Central Zoo Authority

F. No. 19-256/93-CZA(Vol. VII)(193)(NS) / 544/2016

Sub:- Revised designs of enclosure for Wild dog and White Tiger at Nagaland Zoological Park, Rangapahar, Nagaland - Reg.

WHITE TIGER EXHIBIT (LAYOUT PLAN)

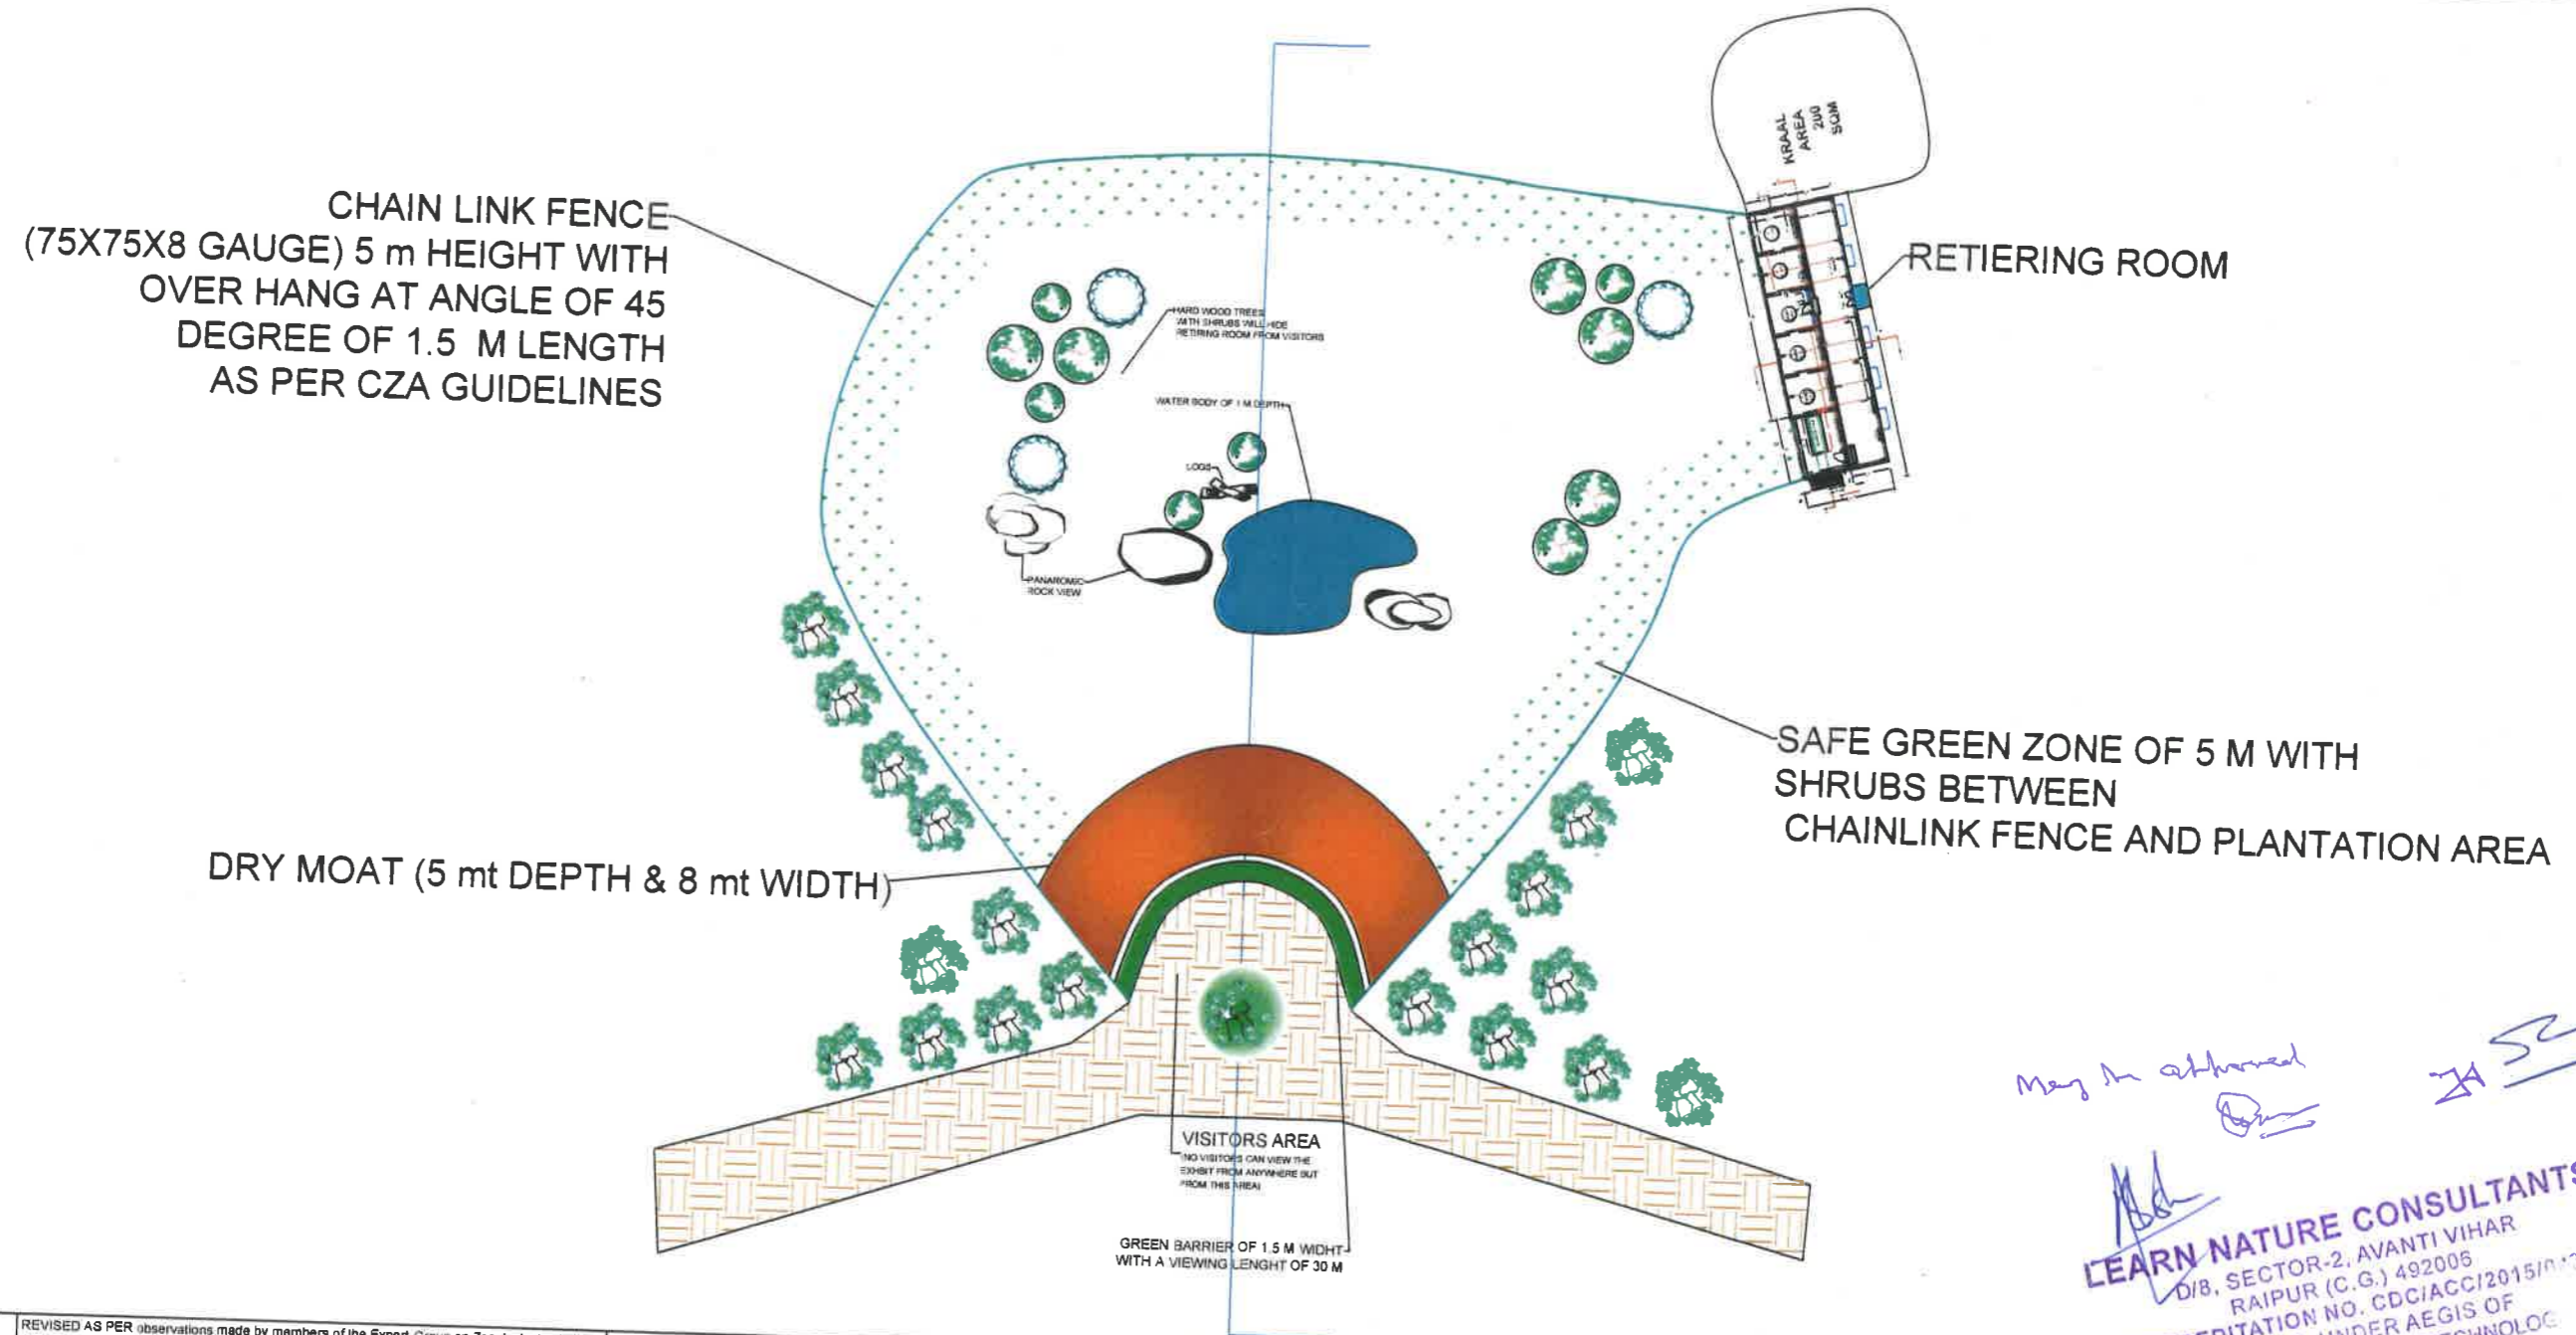
- There should be no feeding stations provided in the fixed grill towards keeper's gallery. Food should be given through sliding gates and central cell.
- There should be proper drainage to take out water from the moat.
